This memorandum has been prepared in response to the request for staff memorandum dated January 24, 2012 in the matter of applications for transfer/new water rights No. 73811, 73834, 63-32499, 61-12095, 61-12096, 63-32703, 61-12256, and 63-33344. The following information was requested:

RE: *Response to IDWR Staff Memo regarding the sufficiency of water supply for water right applications and transfers along the I-84 corridor*

Rebuttal Report of Christian R. Petrich

In the Matter of Application for Transfer No. 73811 (Shekinah Industries); Application for Transfer No. 73834 (Orchard Ranch); Application for Permit No. 63-32499 (Mayfield Townsite); Application for Permit No. 61-12095 (Nevid-Corder); Application for Permit No. 61-12096 (Nevid); Application for Permit No. 63-32703 (Orchard Ranch); Application for Permit No. 61-12256 (Intermountain Sewer & Water); Application for Permit No. 63-33344 (ARK Properties-Mayfield Townsite) before the Idaho Department of Water Resources

Figure 11. Trust area and places-of-use for consolidated applications.

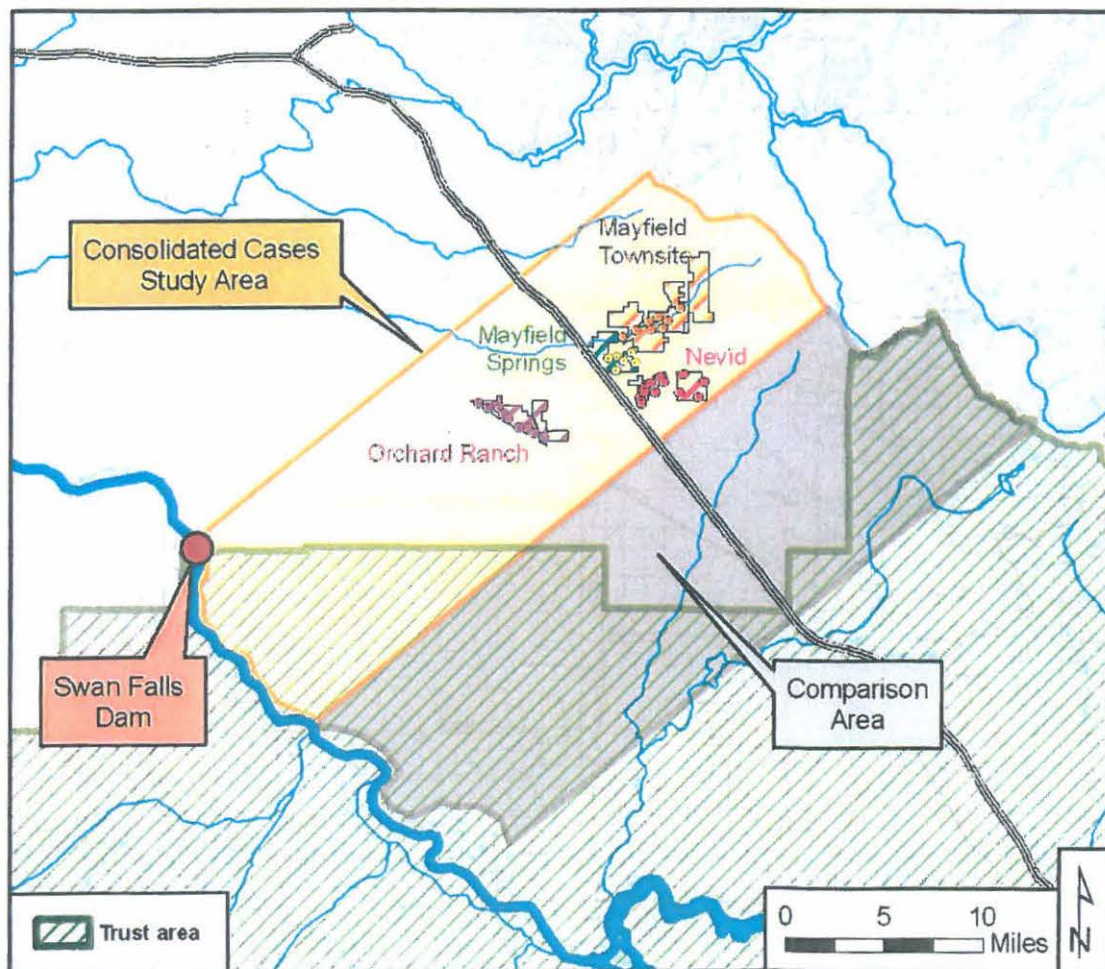
Points of diversion and places of use for the two referenced permits (63-32225 and 61-12090) are not within the trust area boundary defined under IDAPA 37.003.008 (Figure 11). These applications were not protested based on concerns regarding trust water impacts. Consideration of trust water impacts was therefore not required for the processing of these permits. Furthermore, points of diversion and or places of use for applications that are part of this consolidated administrative process (Applications 63-32499, 61-12095, 61-12096, 63-32703, 61-12256, and 63-33344) also lie outside of the trust area (Figure 11).

Figure 12. Snake River minimum flows.

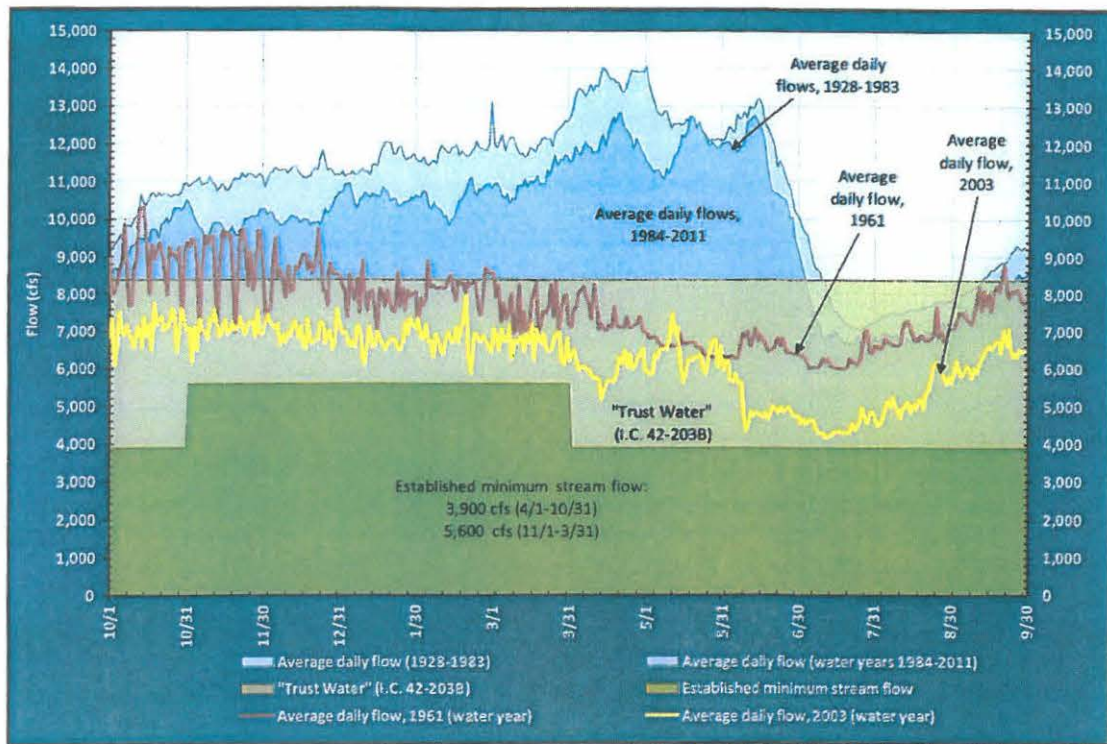
It is important to recognize that average Snake River flows remain well above established minimums. Average daily flows since 1984 (Figure 12) have not only been greater than established minimum flows, but during substantial portions of the year have been greater than the 8,400-cfs generating capacity at Swan Falls Dam. Approval of consolidated-case applications and transfers would represent absolutely no impact to hydroelectric generation during times of the flows greater than 8,400 cfs.

Recent low-flow years (e.g. 2003 – see Figure 12) have seen average daily flows less than 8,400 cfs (but more than minimum flows). However, hydropower rights

Based on the hydrographs in Figure 12, it appears unlikely that a future dip below established minimum flows, if it occurs, would have a long duration. Non-approval of the proposed consolidated-case applications and transfers because Snake River flows may dip below established minimums for a short period of time sometime in the future would preclude the full economic development of the study-area groundwater resource as provided under Idaho Code § 42-226. Furthermore, attempting to prevent a dip in minimum flows by disapproval of these consolidated applications and transfers would be futile because of the relatively small amount of water involved¹⁴.
